Access Compliance Report

Public Rights-of-Way

(Curb Ramps)

Intersection ID: 44167	Main Street: BRANDYBUCK_LN	Cross Street: COCHRANE_DR	Location: NW
ADA ID: 52AFB4E9BD5C	Ramp Type: BlendTrans1	Initial Pass/Fail: Fail	Overall Compliance: No
Severity Score: 35			
Codes/Mitigation Info/Possible Solution		Field Measurements/Component Compliance

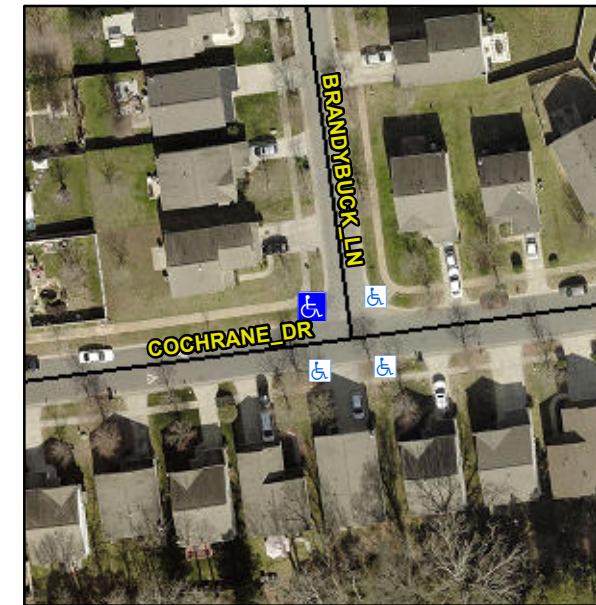
Not Found, R304.5.1

Compliance	Description	Data	Compliance	Description	Data
N/A	Ramp Length (in)	84.5	Yes	BlendTrans Slope (%)	4.6
No	Ramp Width (in)	28.0	Yes	BlendTrans XSlope (%)	1.0
N/A	Flare Type LT	N/A	N/A	Flare Type RT	N/A
N/A	Flare Slope LT (%)	N/A	N/A	Flare Slope RT (%)	N/A
N/A	Flare Traversable LT?	N/A	N/A	Flare Traversable RT?	N/A
N/A	Landing Length (in)	N/A	N/A	DWS Provided?	N/A
N/A	Landing Width (in)	N/A	N/A	DWS Contrast?	N/A
N/A	Landing Slope (%)	N/A	N/A	DWS Length (in)	N/A
N/A	Landing X Slope (%)	N/A	N/A	DWS Full Width?	N/A
N/A	Landing Curb? (Y/N)	N/A	N/A	DWS Offset (in)	N/A
N/A	Shared Landing?	N/A			
N/A	Gutter Ponding?	N/A	N/A	Gutter Slope (%)	N/A
N/A	Gutter Lip Ht (in)	N/A	N/A	Gutter X Slope (%)	N/A
N/A	Painted X Walk1?	No	N/A	Painted X Walk2?	No
	X Walk 1 Direction	To S		X Walk 2 Direction	To E
	X Walk 1 Width (in)	N/A		X Walk 2 Width (in)	N/A
	X Walk 1 Slope (%)	0.8		X Walk 2 Slope (%)	2.1
	X Walk 1 X Slope (%)	2.3		X Walk 2 X Slope (%)	0.3

N/A	Ramp inside XWalk1?	N/A	N/A	Ramp inside XWalk2?	N/A
	Road Slope (%)	2.4		Clear Space?	N/A
	Road X Slope (%)	0.8	N/A	Clear Space to XWalk (in)	N/A
N/A	Any Obstructions?	N/A	N/A	Storm Grate/Utility Hazard?	N/A
	Obstruction Type			Storm Grate/Utility Type	
		N/A			N/A
			Yes	Surface Condition? (G/P)	Good
			No	Curb Slope (%)	11.7

Remove & Replace Curb Ramp With Two New Directional Ramps or Equivalent.
